Staff Packet

Zoning Map Amendment
3000 Block of Commerce Parkway, La Grange, Parcel No. 39-00-00-2A

DEVELOPMENT PLAN
WAREHOUSE COMMERCE PARKWAY
DEVELOPER
GLENVIEW PARTNERS
6363 POPLAR AVE SITE 240
MEMPHIS, TN 38119

TRC-26-016 Glenview Partners, HWY 146

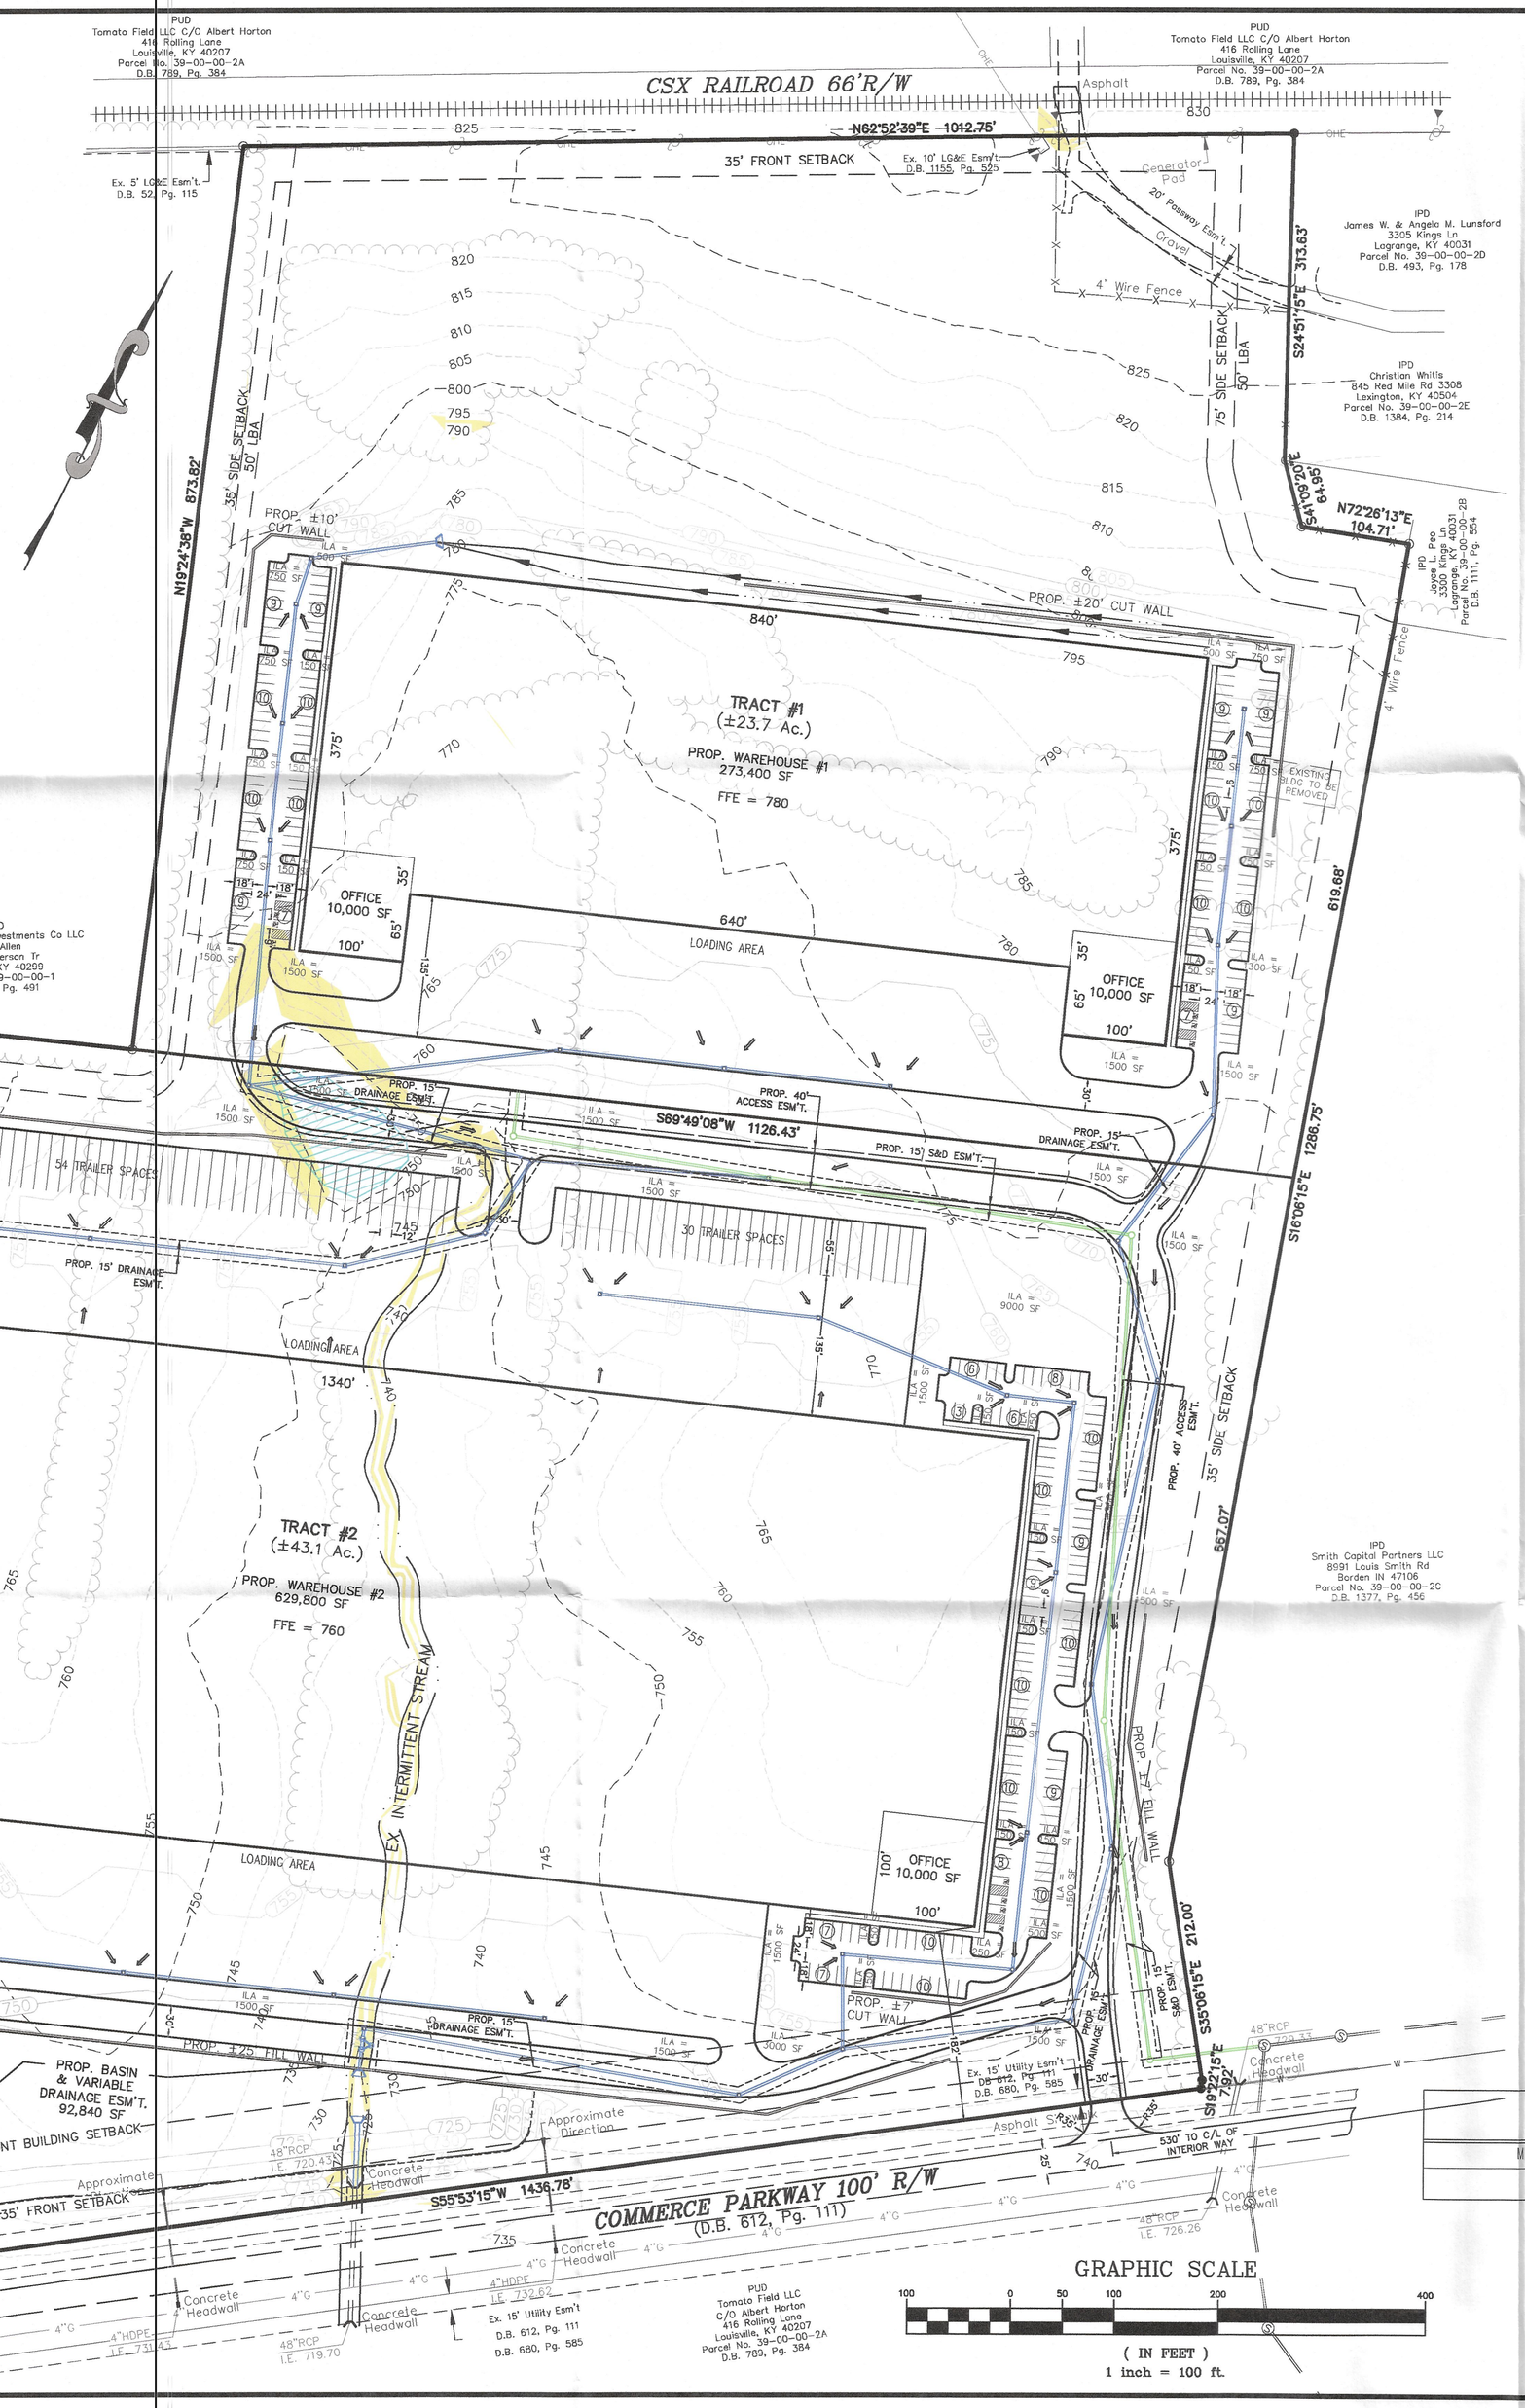
1. Indicate the areas of substantial trees including a general description of their type and sizes.
2. Indicate lakes, ponds, marshes, wetlands, and soil types.
3. Note whether there are any areas of steep slope (over 30%).
4. Indicate the provisions for screening, buffering, and landscaping.
5. Indicate proposed building height.
6. Indicate 20,000 SF Office location in tract 2 drawings or adjust parking to 100 spaces less.
7. Clarify office versus warehouse space on drawing, then recalculate lot area coverage if applicable.
8. Clarify where truck loading area will occur on drawing.
9. Recalculate square foot calculation from acreage under Project Data.

a. 1) The 2025 Commerce Parkway Traffic Study indicates 3 potential access points. The proposed plan reduces that to one entrance.

2) That proposed entrance is approximately 440' west of Interior Way. The Commerce Parkway Traffic Study proposes a spacing of 720' from Interior Way. It appears the single proposed entrance may be realigned approximately 90' to the west increasing the spacing from Interior Way to approximately 530'. This can be done by maintaining the street intersection standards within the Oldham County Subdivision Regulations that require the road be at a 90 degree angle a distance of at least 50' from the intersecting road.

3) For further reference, Commerce Parkway is currently indicated as a Major Urban Collector Street within Kentuckiana Regional Planning and Development Agency (KIPDA) mapping. Based on Section 320-030 of the Oldham County Comprehensive Zoning Ordinance, the driveway spacing shall be at least 300 feet and spacing between major intersections between 300' and 600'.

4) Considering this information, I recommend the intersection of the proposed entrance with Commerce Parkway be shifted approximately 90' to the west as noted above.

b. We recommend the applicant design the planned entrance encroaching onto Commerce Parkway to comply with the KYTC D5 Standard Commercial Entrance detail.

c. Pavement cross section was not provided with the plan. This shall be provided on the plan submitted for the Planning Commission hearing.
d. Pursuant to Section 6.3.C of the Oldham County Subdivision Regulations, the paved traffic areas shall be curbed.

f. The applicant shall ensure the internal pavement geometry can accommodate potential vehicles using the pavement (e.g., emergency vehicles, garbage trucks, delivery trucks, etc.). This shall be shown through turning movement diagrams during the construction plan review process.

3. Stormwater Runoff and Water Quality:
a. Since the land-disturbance area is equal-to or greater-than one (1) acre, stormwater detention or retention and water quality treatment will be required per Oldham County Ordinance No. 16-830-348. The applicant will be required to provide these calculations with their SWQMEC permit application.

b. Water quality treatment will be required per Sections 5.3 and 6.0 of the Oldham County Ordinance Post-Construction Stormwater Control Ordinance
c. New detention/retention basins shall have the following attributes:

1) No trees will be permitted within the 100-year WSE of the basin.
2) The outlet headwall of the detention basin should be set-back 15-ft from the property line.

3) The emergency spillway shall not be earthen. It shall incorporate an appropriate channel lining.
d. The detention/retention basins shall be encompassed by a drainage easement, which shall be recorded with the Oldham County clerk with an associated Long-Term Stormwater Maintenance Agreement. Please note, the release of erosion control surety may be delayed until this easement has been recorded with the county clerk.

e. To ensure this project remains compliant with typical construction phasing and sequencing, Oldham County Engineering will require the detention basins be built first and act as sediment basins for the duration of the project. Oldham County Engineering will not permit building foundations/pads, roadways, or any other hardscapes to be constructed prior to the completion of the sediment basins. This requirement shall be clearly outlined in the construction plan's Phasing and Sequencing notes.

Brian Claybern, LaGrange Fire & Rescue Department
- Show FDC locations; ensure within 100 feet of hydrants.
- Hydrants no more than 300 feet spacing around the property.
- Consider rear access for tract 1 building.

- There is currently no water in front of this property so it will require an extension.
